ASSESSING THE INTEGRITY OF THE SECONDARY CONTAINMENT LINER AT VALDEZ MARINE TERMINAL

Craig H. Benson, PhD, PE, NAE
Wisconsin Distinguished Professor Emeritus
University of Wisconsin-Madison

1 May 2024

Pilot Study Location

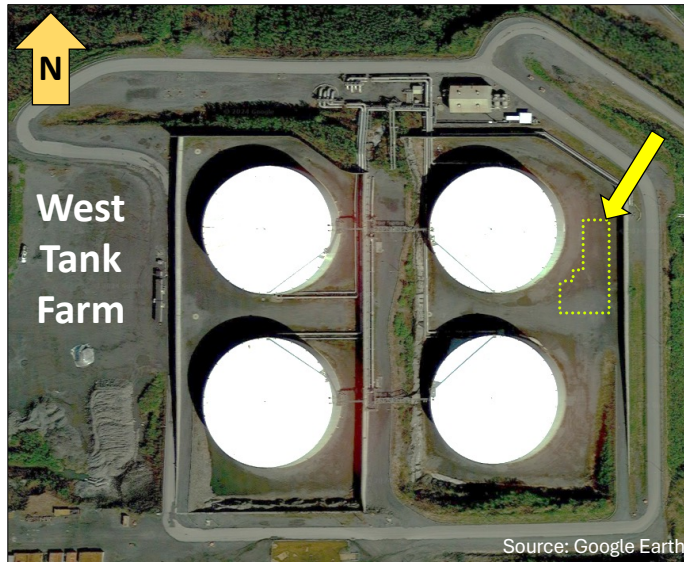
- 1-m transect spacing
- Transects on N-S & E-W orientation
